**PROCESS CHANGE NOTICE**
 **PRODUCT CHANGE NOTICE**

# MAX98357A/MAX98357B

## PCM Input Class D Audio Power Amplifiers

### Simplified Block Diagram

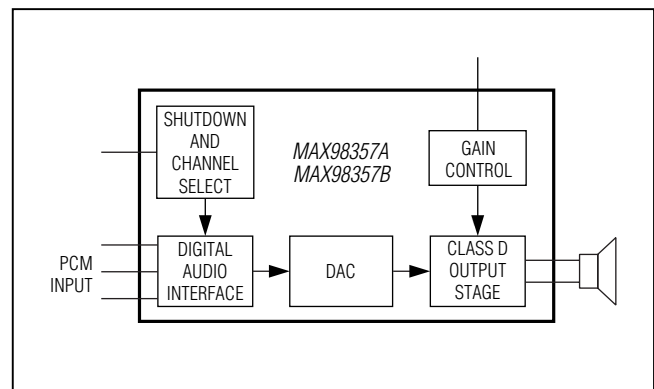
Please add a condition for TQFN that only spec's the typical THD+N with no max spec. Add WLP to the existing condition box that has the max spec as shown below.

| PARAMETER                                   | SYMBOL           | CONDITIONS  | MIN   | TYP   | MAX  | UNITS             |
|---|------------------|---|---|-------|------|-------------------|
| Total Harmonic Distortion + Noise           | THD+N            | f = 1kHz, P <sub>OUT</sub> = 1W, T <sub>A</sub> = +25°C,<br>Z <sub>SPK</sub> = 4Ω + 33μH <b>WLP</b> |   | 0.02  | 0.06 | %                 |
